Project	IEEE 802.16 Broadband Wireless Access Working Group < http://ieee802.org/16 >
Title	Figure Change
Date Submitted	2007-01-18
Source(s)	Peretz Feder, Honghai Zhang ALU pfeder@alcatel-lucent.com , hozhang@alcatel-lucent.com Pbarber@huawei.com
Re:	
Abstract	Additional Hand over primitives for Mobile Side
Purpose	Adoption
Notice	This document has been prepared to assist IEEE 802.16. It is offered as a basis for discussion and is not binding on the contributing individual(s) or organization(s). The material in this document is subject to change in form and content after further study. The contributor(s) reserve(s) the right to add, amend or withdraw material contained herein.
Release	The contributor grants a free, irrevocable license to the IEEE to incorporate material contained in this contribution, and any modifications thereof, in the creation of an IEEE Standards publication; to copyright in the IEEE's name any IEEE Standards publication even though it may include portions of this contribution; and at the IEEE's sole discretion to permit others to reproduce in whole or in part the resulting IEEE Standards publication. The contributor also acknowledges and accepts that this co

Figure xxx – Primitive flow between NCMS at the MS and the MS when HO is initiated

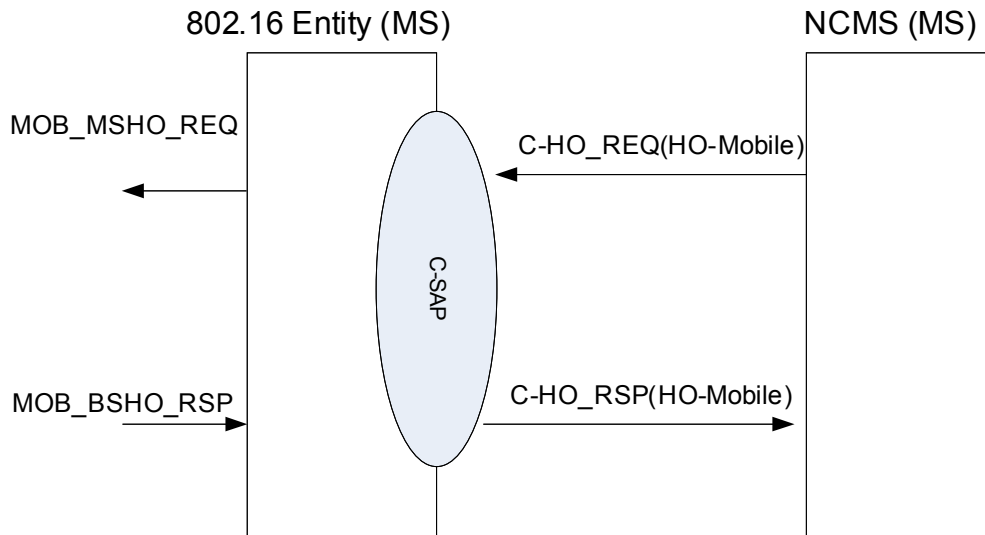
8 The 802.16g draft is missing the trigger for Mobile Initiated Handover. When the NCMS
9 at the MS decides to initiate a handover (as opposed to HO-Start) with the Serving BS it
10 informs the 802.16 MS entity to send a MOB_MSHO-REQ listing the candidate BS for
11 an upcoming HO-Start or HO-Cancel.

21 This primitive is used by the MS or the Mobility Management Services entity in the NCMS at the MS side to
22 indicate the initiation of the HO process. In case of SHO/FBSS, it can be used to update Anchor BS or to add a
23 new Active BS to the current Active set. The NCMS in the MS can use this primitive to inform the 802.16 MS
24 entity to initiate the HO process and inform the serving BS of all the candidate BSs for HO as seen by the MS.
